Central Services Facility

PROVISIONS FOR ENCROACHMENT

RE: ENCROACHMENT APPROVAL FOR DR. OSSIAN SWEET PROJECT SIGN AND CURB

REQUEST ENCROACHMENT
INTO GARLAND ST.
BETWEEN CHARLEVOIX ST.
AND GOETHE ST.

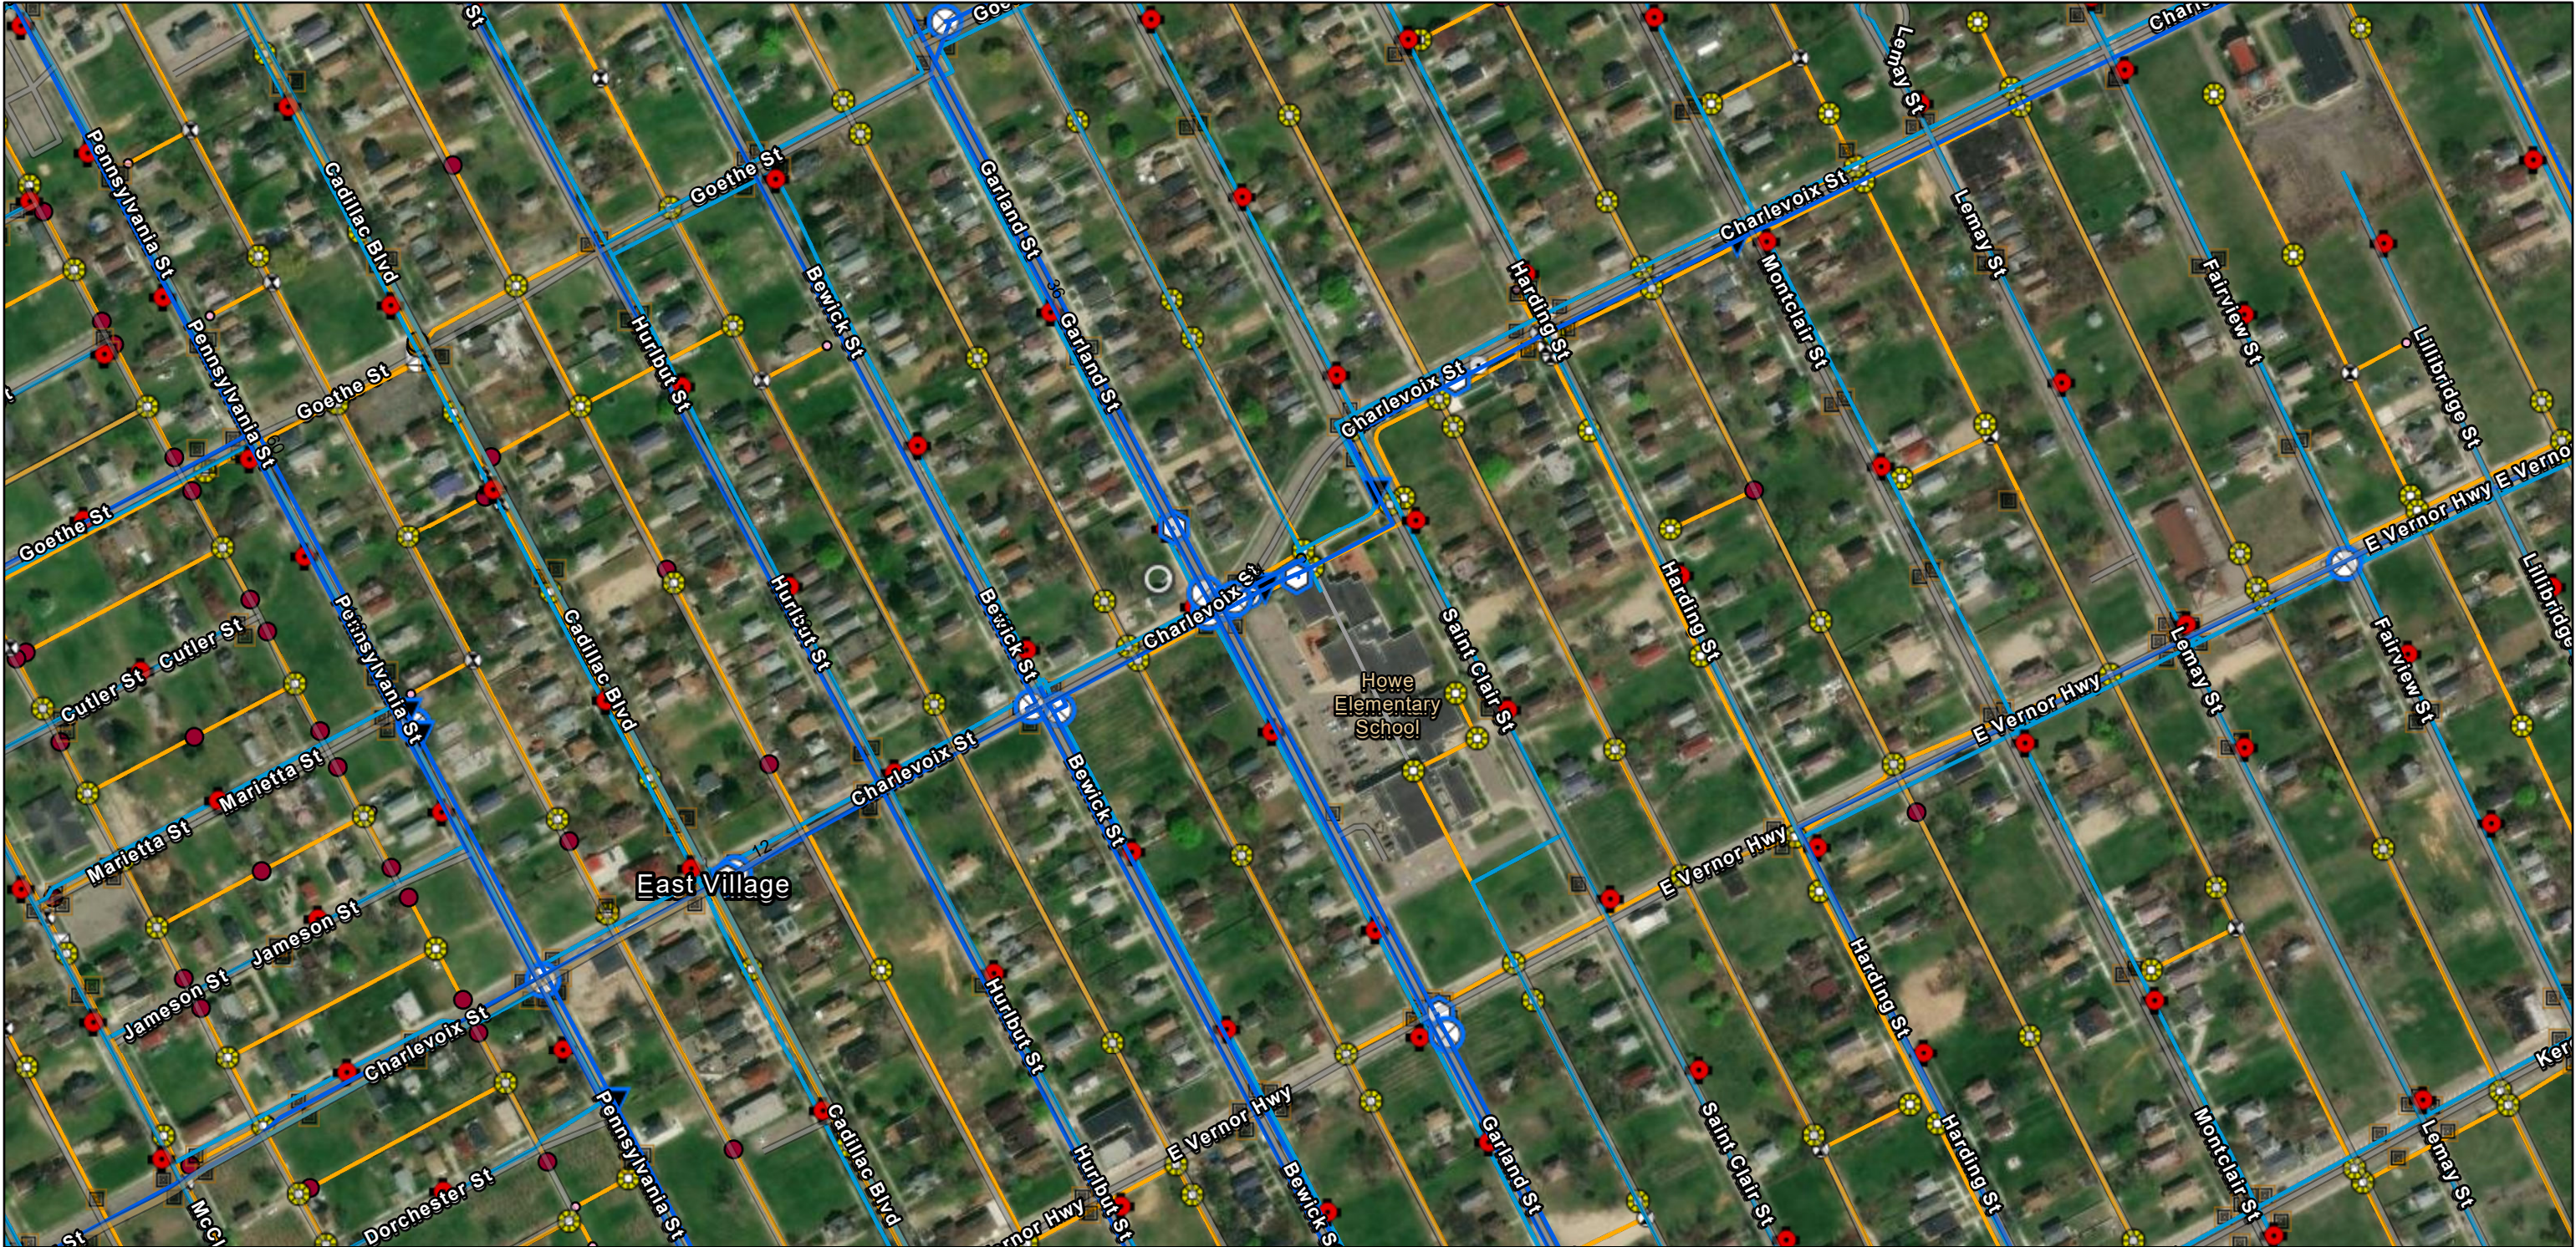
1. By approval of this petition the Detroit Water and Sewerage Department (DWSD) does not waive any of its rights to its facilities located in the right of way, and at all time, DWSD, its agents or employees, shall have the right to enter upon the right of way to maintain, repair, alter, service, inspect, or install its facilities. All costs incident to the damaging, dismantling, demolishing, removal and replacement of structures or other improvements herein permitted and incurred in gaining access to DWSD's facilities for maintenance, repairing, alteration, servicing, or inspection by DWSD shall be borne by the petitioner. All costs associated with gaining access to DWSD's facilities, which could normally be expected had the petitioner not encroached into the right of way shall be borne by DWSD.

2. All construction performed under this petition shall not be commenced until after five (5) days written notice to DWSD. Seventy-two (72) hour notice shall also be provided in accordance with P.A. 53 1974, as amended, utilizing the MISS DIG one call system.

3. Construction under this petition is subject to inspection and approval by DWSD. The cost of such inspection shall, at the discretion of DWSD, be borne by the petitioner.

4. DWSD prohibits the use of heavy construction equipment or the storage of building material directly over or near DWSD facilities. DWSD also prohibits the use of cranes and balls or hydraulic rams for pavement removal where DWSD facilities are involved. If the water main or sewer facilities are broken or damaged as a result of any action on the part of the contractor, the contractor shall be liable for all costs incidental to the repair of such broken or damaged water main or sewer facilities. If DWSD facilities located within the street shall break or be damaged as the result of any action on the part of the petitioner, then in such event the petitioner agrees to be liable for all costs incident to the repair, replacement or relocation of such broken or damaged DWSD facilities.

5. The petitioner shall hold DWSD harmless for any damage to the encroaching device constructed or installed under this petition, which may be caused by the failure of DWSD's facilities.

6. If at any time in the future the petitioner shall request removal and / or relocation of DWSD's facilities in the street being encroached upon, the petitioner agrees to pay all costs for such removal and/or relocation.

7. Prior to construction, Easement Encroachment Permit (EEP) should be obtained and the insurance required by the EEP should not expire until after completion of the construction.

8. For any proposed work that involves DWSD water mains and/or sewers, an approval and a permit is required from DWSD before commencement of work.
9. It is DWSD's requirement that any proposed utility crossing DWSD water mains and/or sewers perpendicularly must maintain a minimum of 18 inches vertical clearance. Any proposed utility running adjacent to DWSD water mains and/or sewers must maintain a minimum of 10 feet lateral clearance including any conduit and/or manholes walls. No utility is allowed to run along the top of the water main or/or sewer.

10. It is DWSD's requirement that no encroachment has a vertical clearance of less than 16 feet from the ground surface over DWSD water mains and/or sewers.
